APPLICATION FOR SUBMITTAL OF POST-APPROVAL DOCUMENT

ADDENDUM 1

Murrieta Valley High School

MVUSD ATHLETIC LIGHTING UPGRADE

AD1 - E1.2

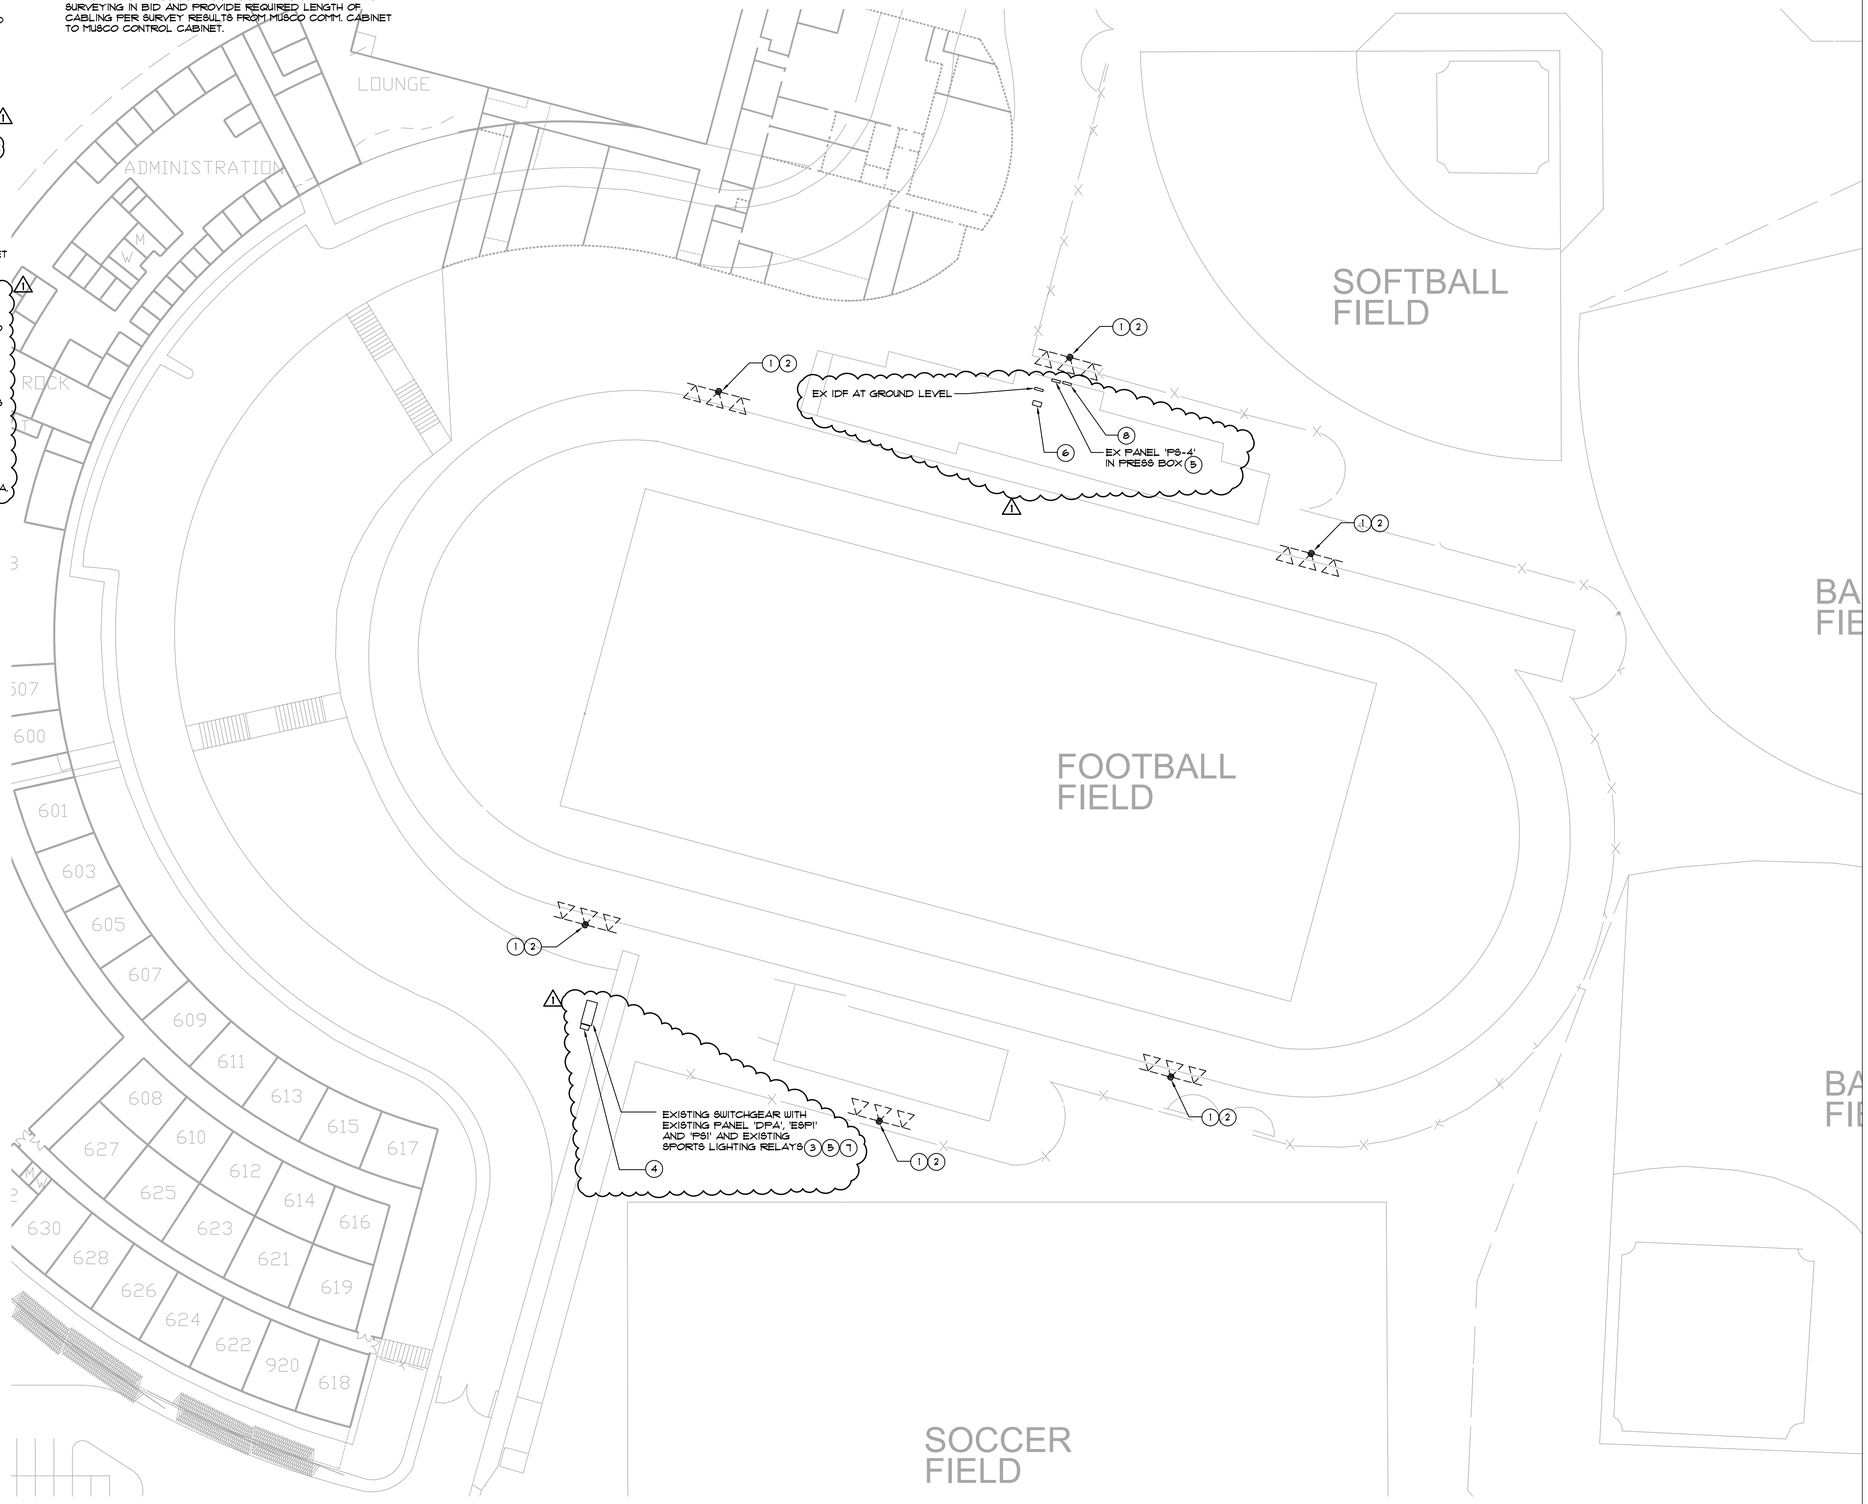
- **A.** Drawing E1.2 – ENLARGED SITE PLAN: Revised currently issued drawing per AD-E1.2
- **B.** Drawing E7.1 – SPORT LIGHTING ONE LINE DIAGRAM: Revised currently issued drawing per AD-E7.1

1. EXISTING SPORTS LIGHTING POLE TO REMAIN. REMOVE EXISTING 'MUSCO' LIGHTS, CROSSARMS, CAPS, BRACKETS AND ALL OTHER EXISTING LIGHT FIXTURES SUPPORTS. REPLACE WITH NEW MUSCO LED LIGHTS, MUSCO FACTORY PROVIDED CROSSARMS, CAPS, BRACKETS AND ALL OTHER NEW LED LIGHT FIXTURE SUPPORTS . PROVIDE ALL REQUIRED MUSCO FACTORY WIRING EXTENSIONS, WIRING HARNESS, BRACKETS AND ALL NECESSARY PARTS TO MAKE A COMPLETE MUSCO SPORTS LIGHTING SYSTEM. EXTEND EXISTING NORMAL AND EMERGENCY LIGHTING CIRCUITS TO NEW LED LIGHT FIXTURES AS REQUIRED. COORDINATE ADDITIONAL REQUIREMENTS AND FIXTURE AIMING WITH MUSCO. PROVIDE BIRD SPIKES ON TOP OF MUSCO POLES, CROSS ARMS AND ALL NEW MUSCO LED LIGHT FIXTURES.

2. DISCONNECT AND REMOVE EXISTING BALLAST ENCLOSURE AND REPLACE WITH NEW COMPLETE AND FULLY FUNCTIONAL LED DRIVER ENCLOSURES AS REQUIRED.
3. ALL EXISTING CONDUCTORS TO REMAIN. EXTEND TO NEW MUSCO CONTROL CABINET AS REQUIRED. REMOVE EXISTING MUSCO CONTROL SWITCH. PROVIDE 120V POWER CONNECTIONS FROM EXISTING SPARE BREAKERS IN PANEL 'PS1', AND EXTEND TO MUSCO CONTROL CABINET, ALIC, AND COMM. CABINET. PROVIDE 3/4"C. 2 #12, 1 #12 GND. FROM EACH BREAKER TO ASSOCIATED CABINET.

4. NEMA 3R MUSCO CONTROL CABINET, NEMA 3R REMOTE RELAY CABINET AND NEMA 3R MUSCO COMM. CABINET. MOUNT TO SIDE OF EXISTING SWITCHBOARD.
5. PROVIDE (1) WP/GFI DUPLEX RECEPTACLE IN SECTION CONTAINING BREAKERS FOR SPORTS LIGHTING ON SIDE PANEL BEYOND DEADFRONT COVER. PROVIDE CUSTOM MADE BRACKET FOR MUSCO CONTROL TOUCH SCREEN. COORDINATE EXACT BRACKET WITH MUSCO.

6. NEMA 3R REMOTE RELAY. MOUNT TO EXTERIOR OF PRESS BOX BUILDING UNDER BLEACHERS OUTSIDE OF ELECTRIC ROOM. PROVIDE (1) 20A/1P BREAKER IN PANEL 'PS-4' AND 3/4"C. 2#12, #12GND FROM BREAKER TO CABINET. PROVIDE 1"C. FROM MUSCO COMMUNICATION CABINET TO CABINET AND 1"C. FROM COMMUNICATIONS CABINET TO THE CEILING OF THE PRESS BOX FOR ANTENNA.

7. MOUNT ALIC CABINET INSIDE SWITCHGEAR ABOVE THE PANEL 'DPA' SECTION. PROVIDE NIPPLE THROUGH TO ACCESS THE SECTION WITH PANEL ESPI. PROVIDE 120V POWER CONNECTIONS FROM PANELS 'PS1' AND 'ESPI'. PROVIDE 3/4"C. 2 #12, 1 #12 GND. FROM EACH BREAKER TO ALIC CABINET.

8. NEMA 1 COMMUNICATION CABINET. MOUNT IN MAIN ANNOUNCING AREA IN PRESS BOX. PROVIDE (1) 20A/1P BREAKER IN PANEL 'PS-4' AND 3/4"C. 2#12, #12GND FROM BREAKER TO CABINET. PROVIDE 1"C. FROM IDF TO CABINET WITH CAT 6 CABLE ANTENNA.

AD1 - E7.1

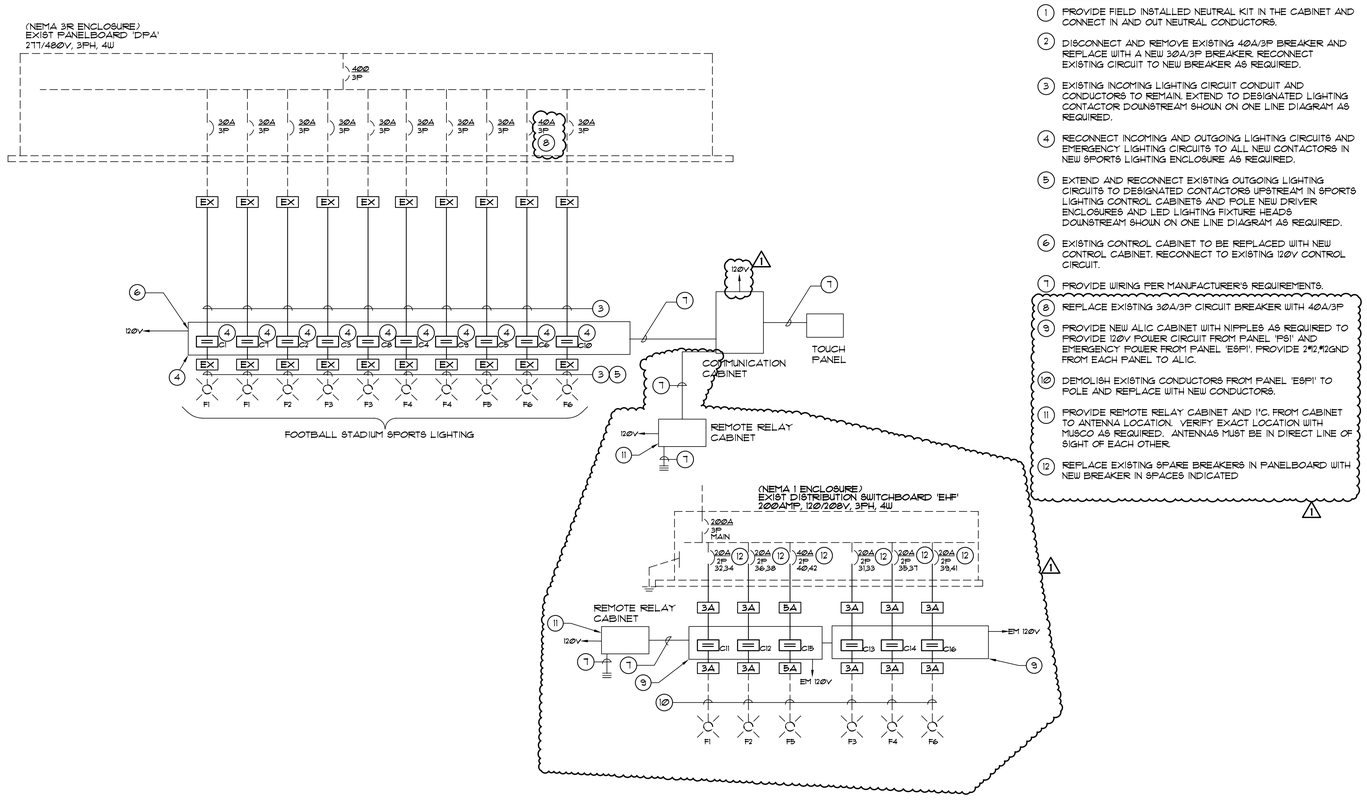
1. PROVIDE FIELD INSTALLED NEUTRAL KIT IN THE CABINET AND CONNECT IN AND OUT NEUTRAL CONDUCTORS.
2. DISCONNECT AND REMOVE EXISTING 40A/3P BREAKER AND REPLACE WITH A NEW 30A/3P BREAKER. RECONNECT EXISTING CIRCUIT TO NEW BREAKER AS REQUIRED.

3. EXISTING INCOMING LIGHTING CIRCUIT CONDUIT AND CONDUCTORS TO REMAIN. EXTEND TO DESIGNATED LIGHTING CONTACTOR DOWNSTREAM SHOWN ON ONE LINE DIAGRAM AS REQUIRED.

4. RECONNECT INCOMING AND OUTGOING LIGHTING CIRCUITS AND EMERGENCY LIGHTING CIRCUITS TO ALL NEW CONTACTORS IN NEW SPORTS LIGHTING ENCLOSURE AS REQUIRED.

5. EXTEND AND RECONNECT EXISTING OUTGOING LIGHTING CIRCUITS TO DESIGNATED CONTACTORS UPSTREAM IN SPORTS LIGHTING CONTROL CABINETS AND POLE NEW DRIVER ENCLOSURES AND LED LIGHTING FIXTURE HEADS DOWNSTREAM SHOWN ON ONE LINE DIAGRAM AS REQUIRED.

6. EXISTING CONTROL CABINET TO BE REPLACED WITH NEW CONTROL CABINET. RECONNECT TO EXISTING 120V CONTROL CIRCUIT.
7. PROVIDE WIRING PER MANUFACTURER'S REQUIREMENTS.

8. REPLACE EXISTING 30A/3P CIRCUIT BREAKER WITH 40A/3P
9. PROVIDE NEW ALIC CABINET WITH NIPPLES AS REQUIRED TO PROVIDE 120V POWER CIRCUIT FROM PANEL 'PB1' AND EMERGENCY POWER FROM PANEL 'ESP1'. PROVIDE 2#2,#12GND FROM EACH PANEL TO ALIC.

10. DEMOLISH EXISTING CONDUCTORS FROM PANEL 'ESP1' TO POLE AND REPLACE WITH NEW CONDUCTORS.
11. PROVIDE REMOTE RELAY CABINET AND 1"C. FROM CABINET TO ANTENNA LOCATION. VERIFY EXACT LOCATION WITH MUSCO AS REQUIRED. ANTENNAS MUST BE IN DIRECT LINE OF SIGHT OF EACH OTHER.

12. REPLACE EXISTING SPARE BREAKERS IN PANELBOARD WITH NEW BREAKER IN SPACES INDICATED
